3/4.4 REACTOR COOLANT SYSTEM

HATCH - UNIT 2

NRC DOCKET 50-366
OPERATING LICENSE NPF-5
EDWIN I. HATCH NUCLEAR PLANT UNIT 2
REQUEST FOR TECHNICAL SPECIFICATION AMENDMENT
TO SUPPORT OPERATION IN THE ELLA REGION

FIGURE 3.4.1.1-1
THERMAL POWER LIMITATIONS DURING OPERATION WITH LESS THAN
TWO REACTOR COOLANT SYSTEM RECIRCULATION LOOPS IN OPERATION

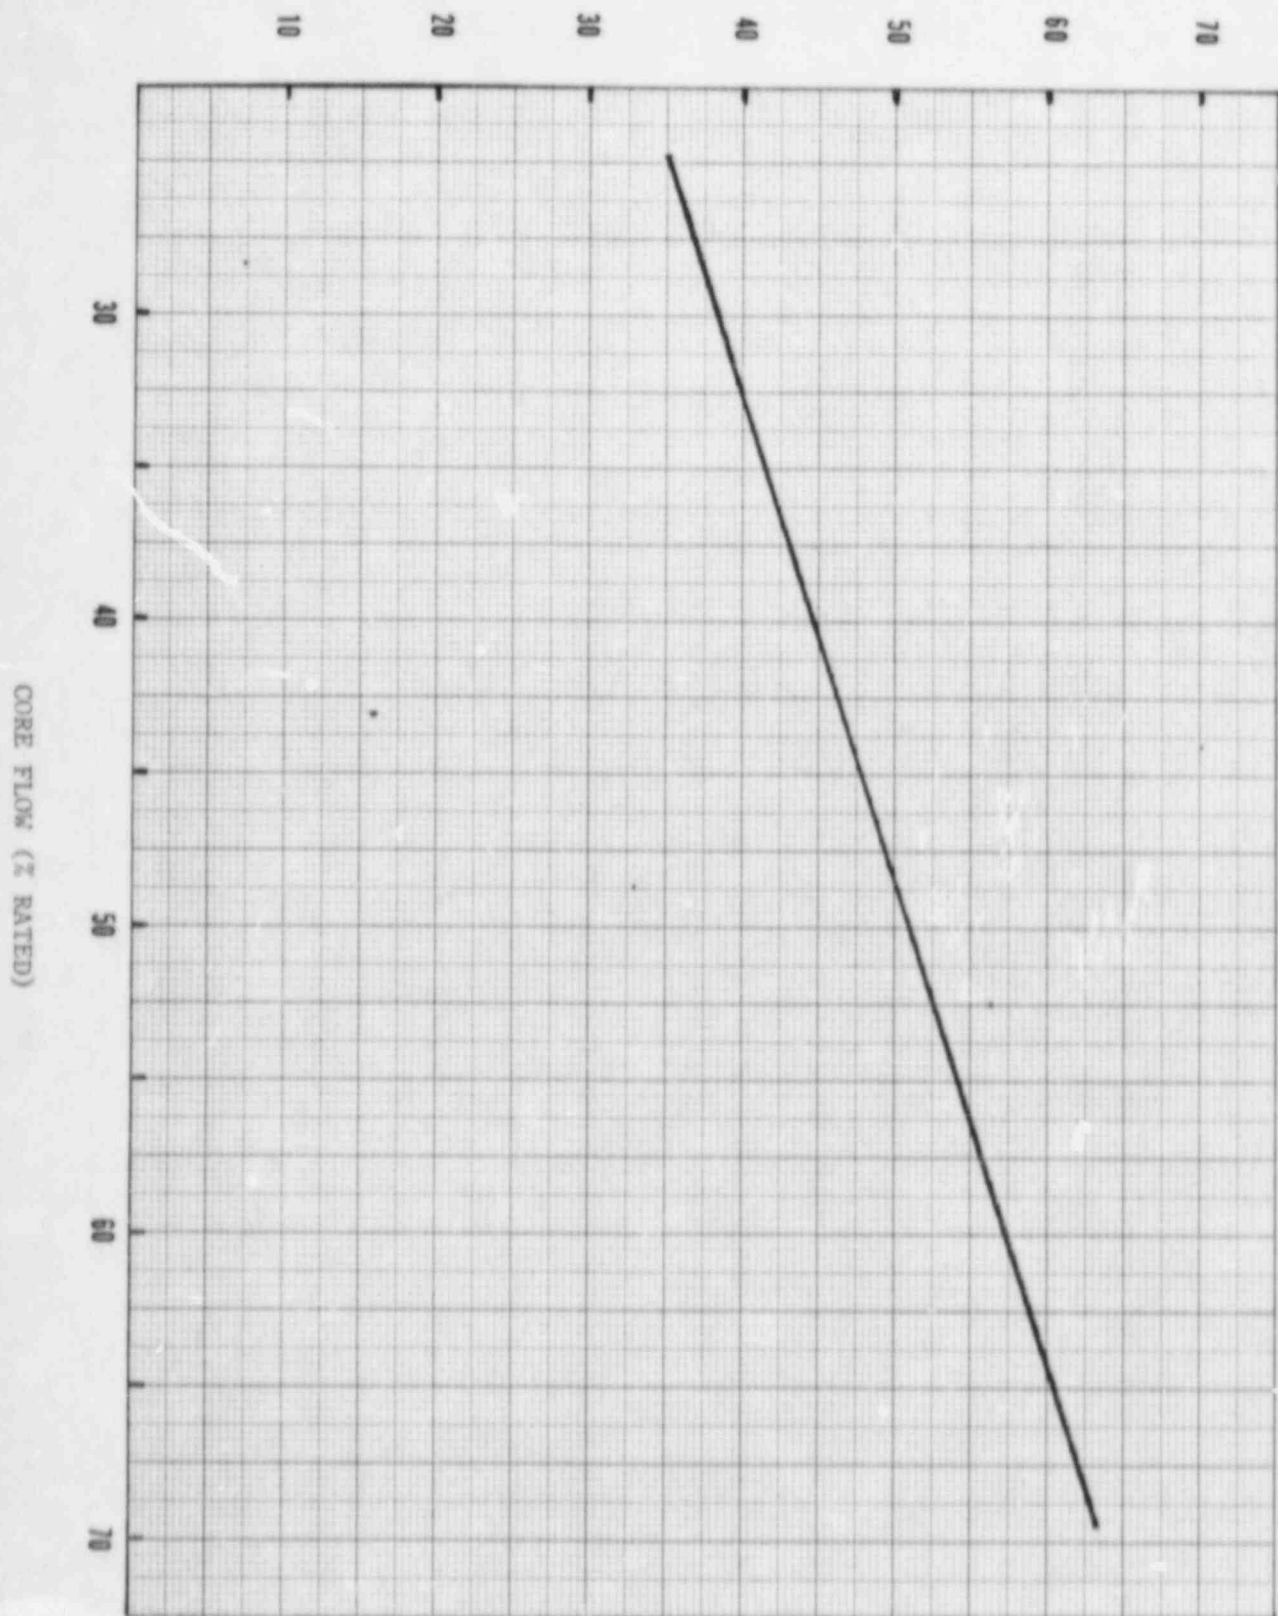
Replace "...operation may continue;..." with "...initiate action within 15 minutes and continue action to reduce reactor power to or below the limit specified in Figure 3.4.1.1-1 within 2 hours and..." in ACTION 3.4.1.1.a, and add Figure 3.4.1.1-1 as a new page (3/4 4-1a).

This change would restrict plant operation to the region at or below the limit shown in Technical Specification Figure 3.4.1.1-1, within 2 hours after either recirculation loop is declared inoperable. That limit corresponds to a load line leading to 80% reactor power at rated core flow. This constitutes an additional restriction not presently in the Technical Specifications; therefore, this proposed change is consistent with Item (ii) of the "Examples of Amendments that are Considered Not Likely to Involve Significant Hazards Considerations" listed on page 14,870 of the April 6, 1983, issue of the Federal Register.

- a. With one recirculation loop not in operation, initiate action within 15 minutes and continue action to reduce reactor power to or below the limit specified in Figure 3.4.1.1-1 within 2 hours and restore both loops to operation within 12 hours or be in at least HCT SHUTDOWN within the next 12 hours.
- b. With no recirculation loops in operation, place the reactor mode switch in the Shutdown position.
